# 19-145 TPC Racing MECHANICAL/ PLUMBING Permit Comments

B22004362 Construct New 1 Story Shell Building 7869 Dorsey Run Road Jessup, Maryland 20794 Email sent to: rbrasher@brasherdesign.com Ron Brasher, Please note the below plan review comments for revision and resubmittal regarding the subject project:

# 19-145 TPC Racing ARCH Permit Comments

This office has reviewed the construction drawings submitted for the above referenced project. The plans indicate an approximate 39948 square foot building. The use group is M , and the construction type is 2B. The following comments are noted for compliance:

CLOPAY COMMERCIAL – MODELS 904, 904U  
**architectural series**

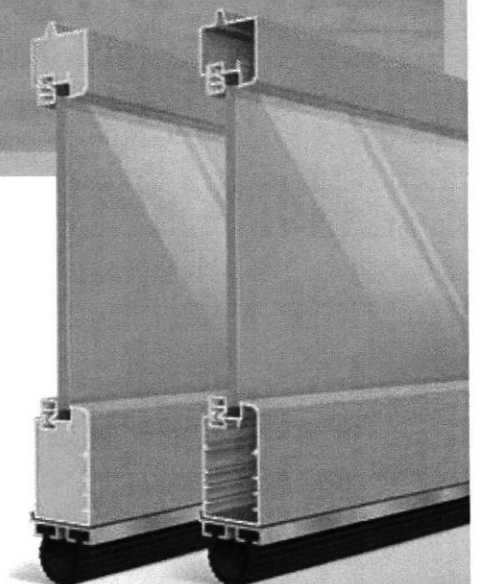
4. Please provide product information on the overhead doors that shows compliance with the air infiltration rate of the 2021 IECC. A note is not acceptable.

4. Please provide product information on the overhead doors that shows compliance with the air infiltration rate of the 2021 IECC. A note is not acceptable.

- b. Cut sheets for overhead doors showing compliance with allowable air infiltration CFM/ft<sup>2</sup>

- b. Cut sheets for overhead doors showing compliance with allowable air infiltration CFM/ft<sup>2</sup>
